SERVICE LETTER

Standardization of the reduction gearbox for ROTAX® 912/914

SL-912-002

SL-914-002

Bild / Fig. 2

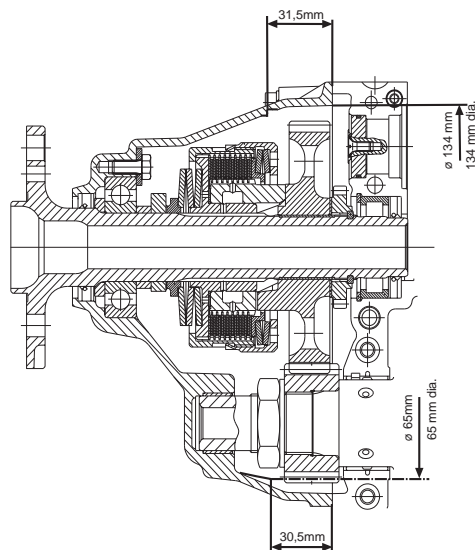
The changed axial position of the drive gear and the dog gear of increased width require extra space in the gearbox housing (see fig. 2).

- **ATTENTION:** The crankshaft part no. 888.164 is allowed to be installed only in the gearbox housing part no. 911.746 as in any other housing the space between gear set and housing wall is inadequate.

Bild / Fig. 3

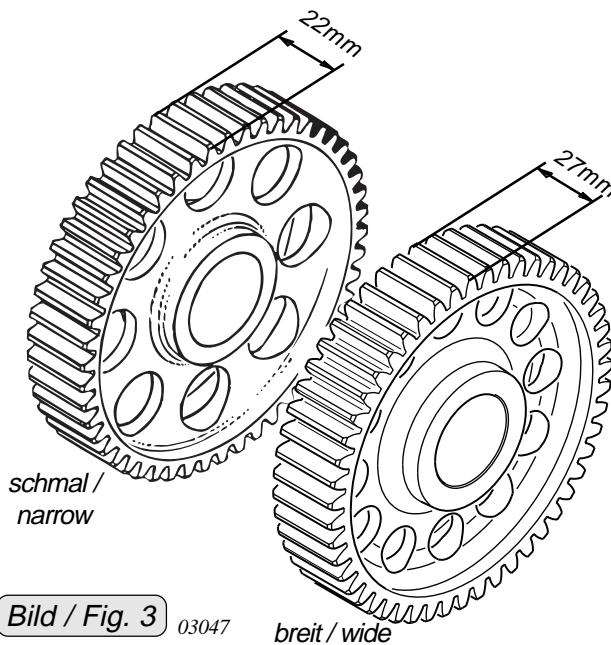
On ROTAX_a 912 ULS, 912 S, 914 UL, 914 F a dog gear of a width increased by 5 mm (0,2 in) was introduced (see fig. 3). This dog gear is part of the gear set 886.518.

Bild / Fig. 4

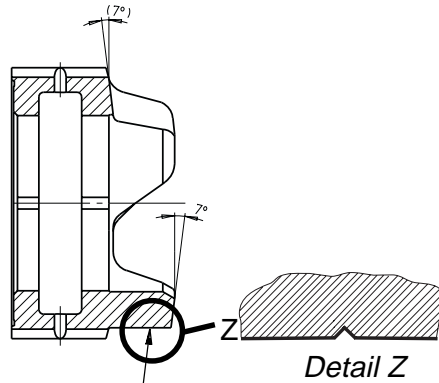
The increase in dog gear width made modification of the dog support surface necessary. The dog support surface is now machined 7° tapered (see fig. 4).

◆ **NOTE:** The new dog hub and dog gear of the overload clutch and the dog gear of increased width can be identified by a groove (see fig. 4).

A gear set of the increased width must be only paired with the 7° tapered dog hub part no. 958.892 and is allowed to be fitted only together with the overload clutch of new design part no. 996.886.

▲ **WARNING:** This dog hub and overload clutch must never be used in connection with a gear set of narrow width as the contact surfaces do not match correctly.

Bild / Fig. 5

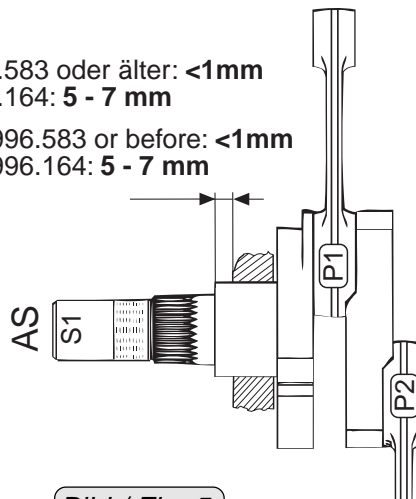
Because of the wider dog gear, it became necessary to change the axial position of the drive gear. Therefore the crankshaft part no. 888.164 is furnished with a longer ending (see fig. 5).

▲ **WARNING:** If the modified crankshaft part no. 888.164 will be installed instead of the previous one (part no. 996.583) take care of the following:

- If the narrow gear set is going to continue to be used, then it will be necessary to inspect the gear set for traces of wear due to axial staggering between drive gear and dog gear. If traces of wear are obvious, exchange the gear set for one of increased width. In this case the overload clutch or dog hub has to be exchanged for use with a 7° dog support face.
- The crankshaft part no. 888.164 is only allowed to be installed into the gearbox housing part no. 911.746 (see chapter 3.1.3)

Bild / Fig. 6

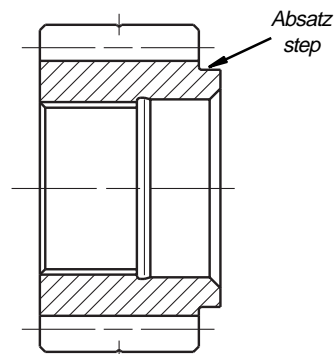
This gear set is necessary if a gearbox with a narrow gear set has to be converted into a gearbox with an increased gear set width and for a crankshaft part no. 996.583 or older.

- ◆ **NOTE:** This gear set is with a drive gear of increased width which compensates for the axial staggering between crankshaft part no. 996.583 and dog gear of increased width.
- ◆ **NOTE:** The interim gear set is only available with reduction ratio 2,43.
- ▲ **WARNING:** This gear set is allowed to be installed only together with a crankshaft part no. 996.583 or of earlier date and in gearbox housing part no. 911.746.
